**Our Case Number:** ACP-323980-25

**Re:** Proposed Water Supply Project for the Eastern and Midlands Region  
in the counties of Clare, Limerick, Tipperary, Offaly, Kildare, and Dublin.

## **Water Supply Project Eastern and Midlands Region**

Figure 1: WSP Hydrological Model: Simulation of the 2018 Drought Including Climate Change: i) Without WSP, ii) WSP =154Mld, iii) WSP = 300Mld (Source: Uisce Éireann, Water Supply Project EIAR, Appendix A9.1, Annex A, Image 2.9)

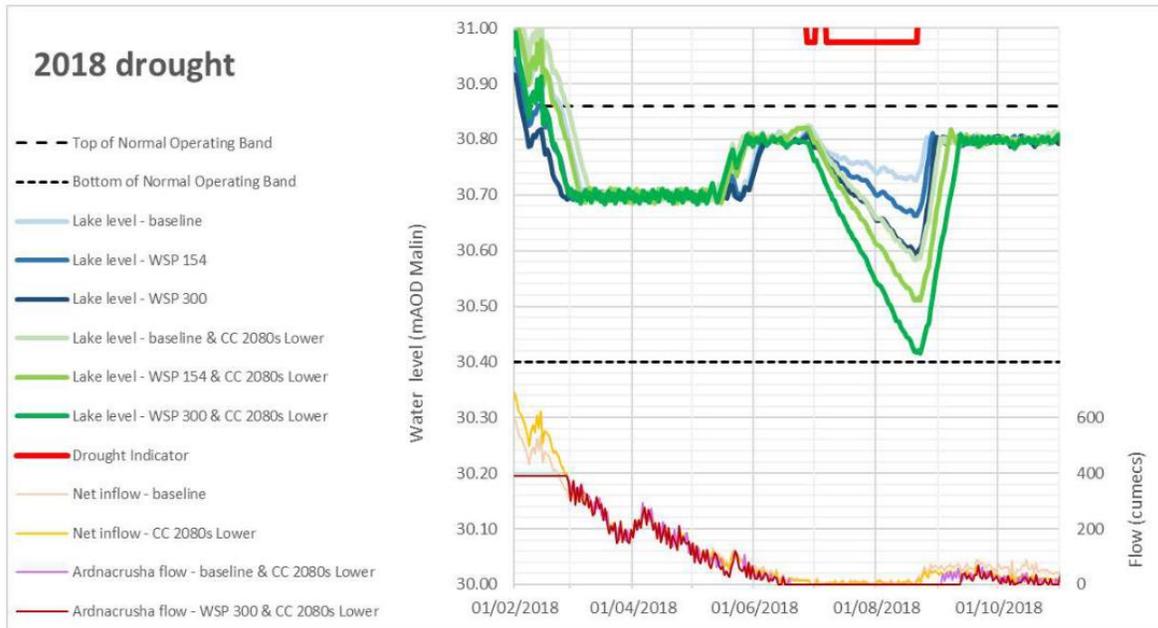
Drawing down Lough Derg to below 30.60m OD - as predicted in the simulation below - may lead to isolated highpoints with insufficient navigational draft.

Given that the required minimum draft on the Shannon Navigation is 1.8m, Waterways Ireland is requesting an assessment of the impacts on navigation in Lough Derg, specifically evaluating the physical viability of accessing the lake via all existing jetties, marinas, and other fixed recreational facilities during drought scenarios that fall below a level of 30.60 mOD.
